**REQUEST FOR SITE PLAN REVIEW OF CNP STORAGE;
CASE OF TSM DEVELOPMENT, INC
By: Amy Geisler, AICP, Associate Planner**

Re: Site Plan – CNP Storage

We are in receipt of a Site Plan, Landscape Plan, Tree Preservation Plan, Utility Plan, and Grading Plan prepared by James R. Hill Inc., dated June 29, 2007, revised July 20, 2007, revised August 8, 2007, revised August 22, 2007. We offer the following comments:

REGENCY POND 4TH ADDITION
 TREE PRESERVATION PLAN
 RAMSEY, MINNESOTA

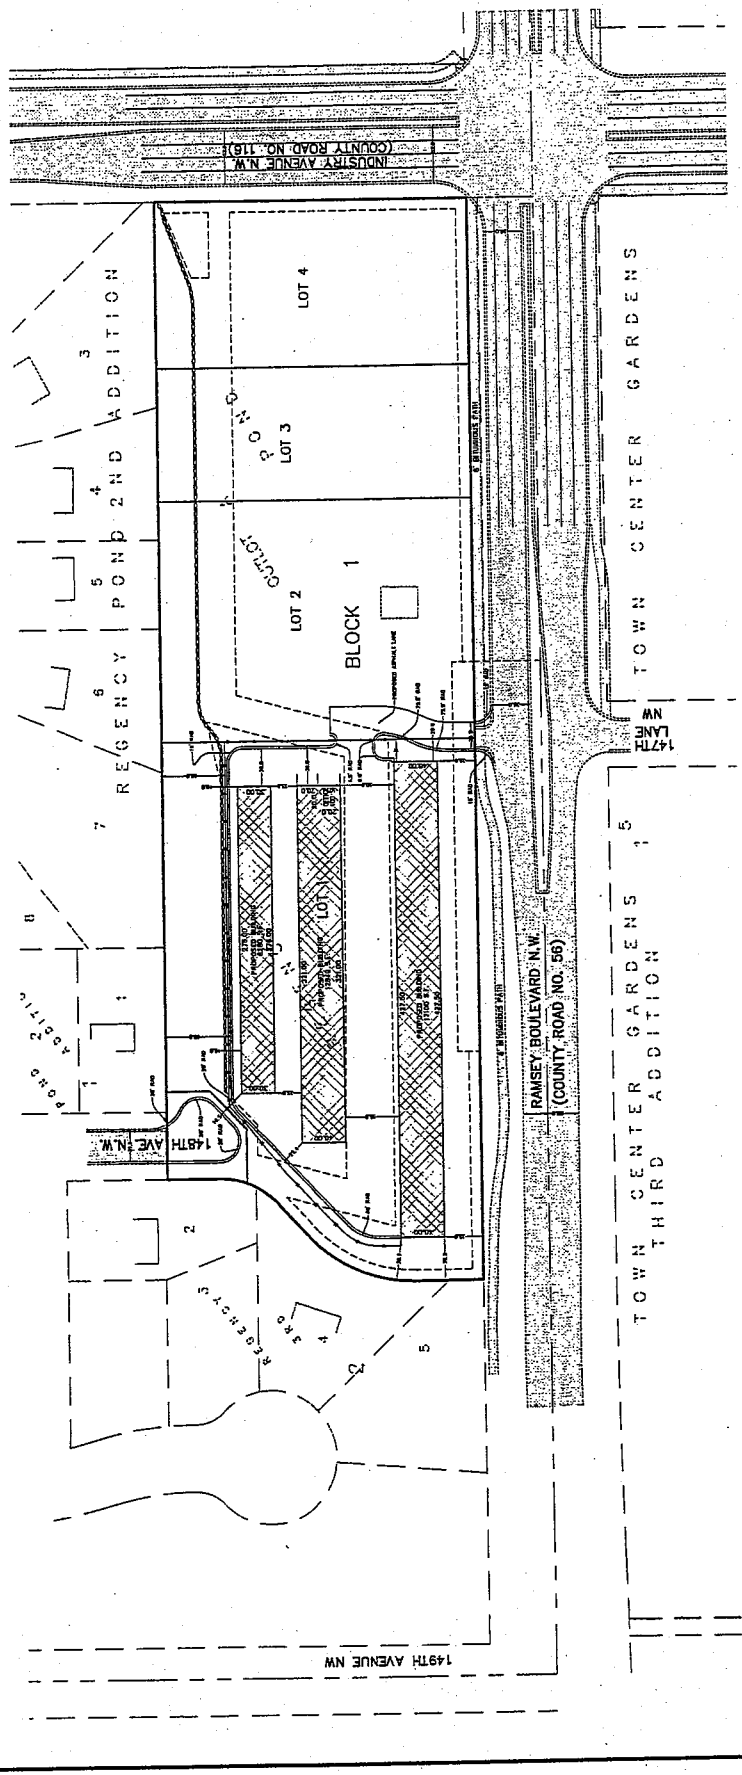
- Tree save fencing must be shown on the tree preservation plan as well as the grading plan. The fencing shall be placed no closer than the dripline of any trees being preserved and shall be in

place prior to any earthwork beginning. If silt fencing is going to double as tree save fencing, it must be clearly indicated on both plans.

NORTH / SOUTH ELEVATION
18'-11-0"

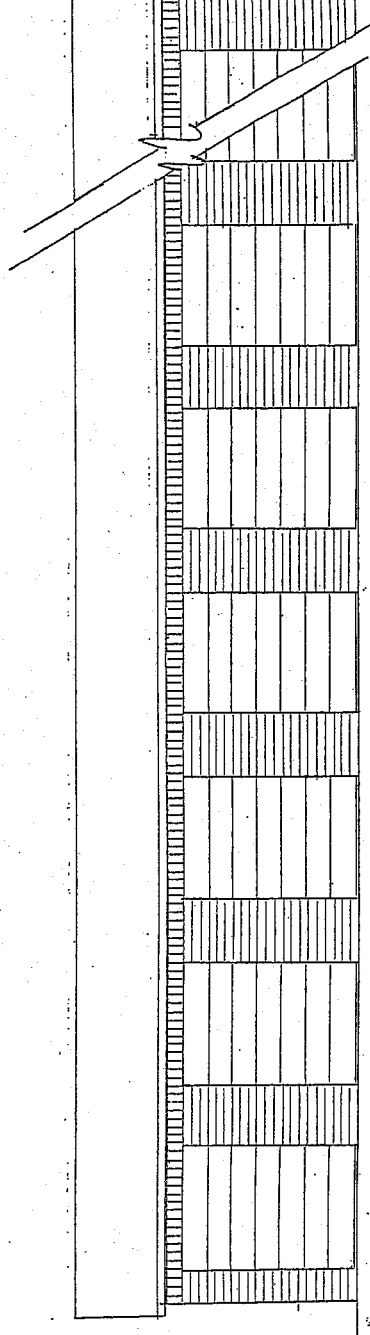
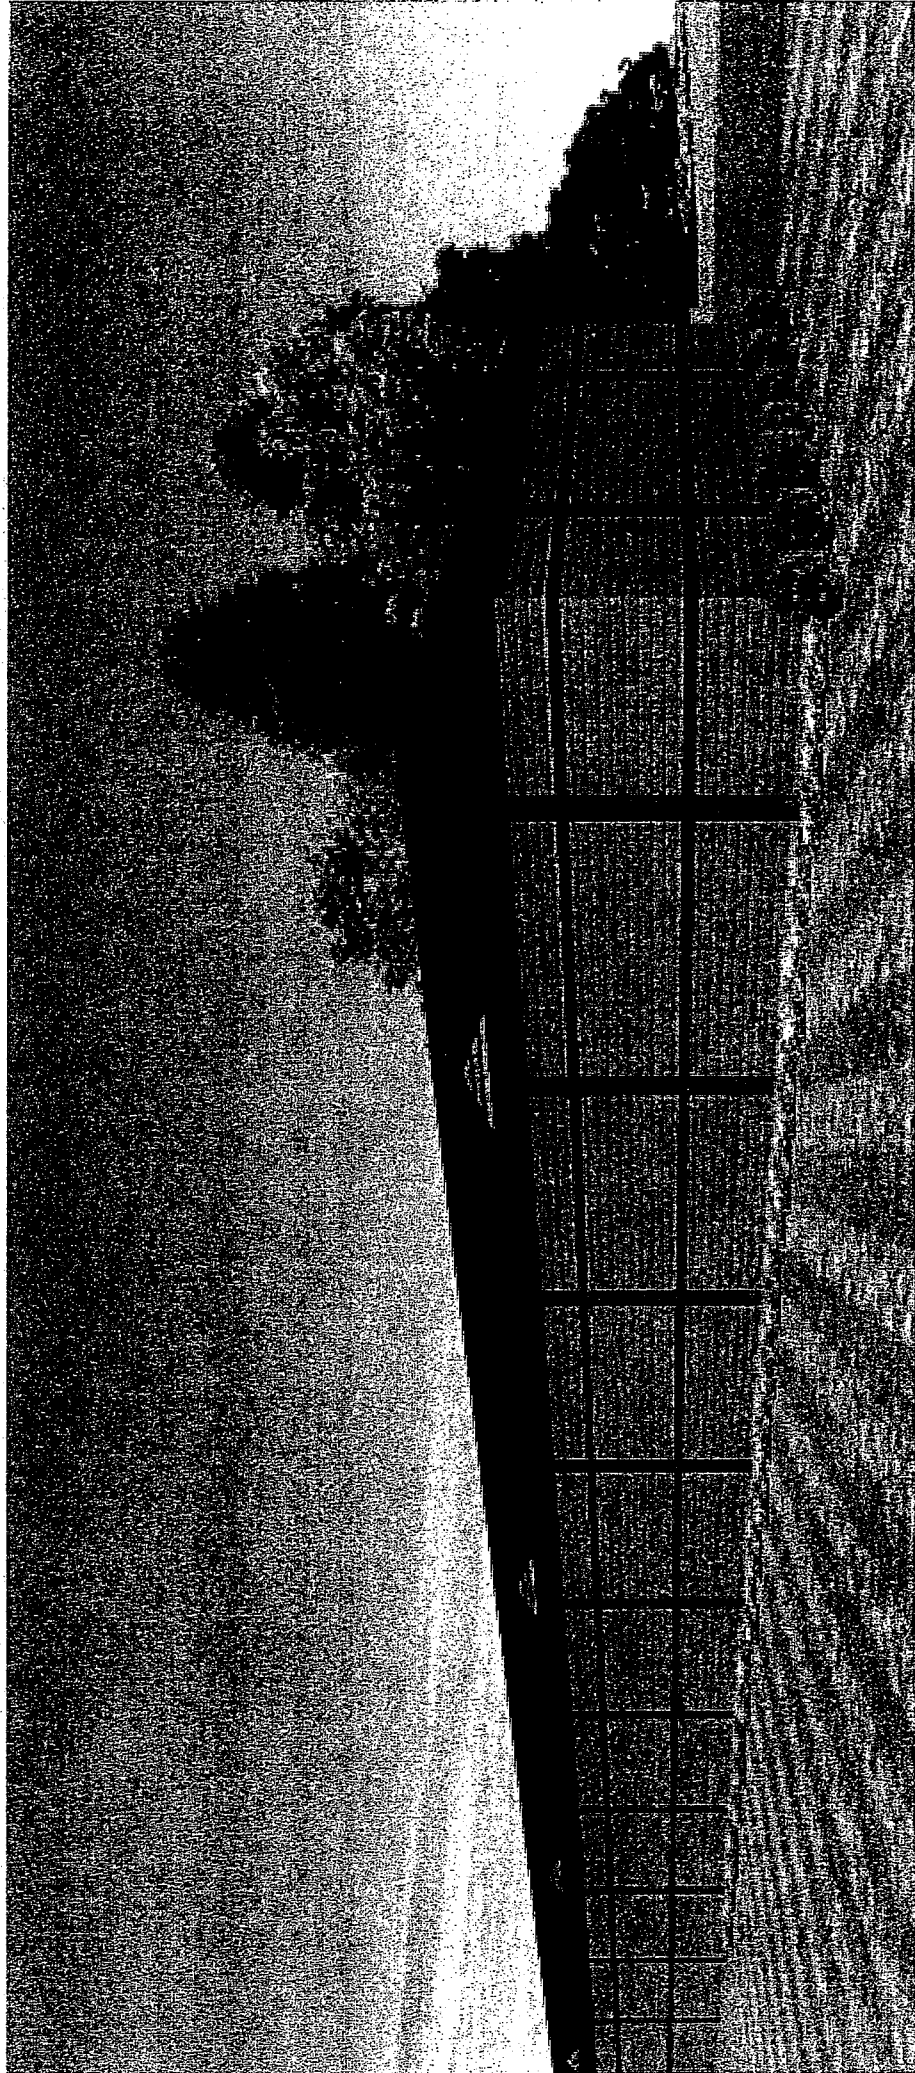
The City Council reviewed the site plan at the October 9, 2007 meeting and had significant discussion about the building elevations. The submitted building elevations indicate that the buildings will consist of rock-face block with vinyl shakes. Vinyl is not typically permitted in the E-1 District, though it may be allowed if approved by the City Council. The Council tabled the site plan and directed the applicant to prepare revised building elevations, to include more articulation in the roofline and building façade of the storage building closest to Ramsey Blvd, and to indicate the height of landscaping at maturity.

The applicant has submitted a color elevation, which includes some additional information on color and building detail. Some small peaks have been added to the roofline. The revised elevations do not give a sense of how the building will appear from Ramsey Blvd with mature landscaping. Staff would suggest Councilmembers take a look at the new storage buildings on the south side of Bunker Lake Blvd, just east of Unity Street. Staff expects the TSM buildings to have a similar appearance from the road (in terms of landscaping). Staff would also add that the landscaping plan shows a large amount of new plantings to be clustered around the Ramsey Blvd entrance, but overall the plantings will thin out (and the building become more visible) moving north from the entrance.

The proposed mini-storage buildings will present a very long façade on Ramsey Blvd. Staff would recommend the City Council consider whether additional improvements to the building elevations themselves are needed. Rather than adding additional landscaping to the mini-storage site, though, Staff would suggest that more attention be paid to the actual corner of Bunker Lake Blvd and Ramsey Blvd when the commercial lots to the south develop.
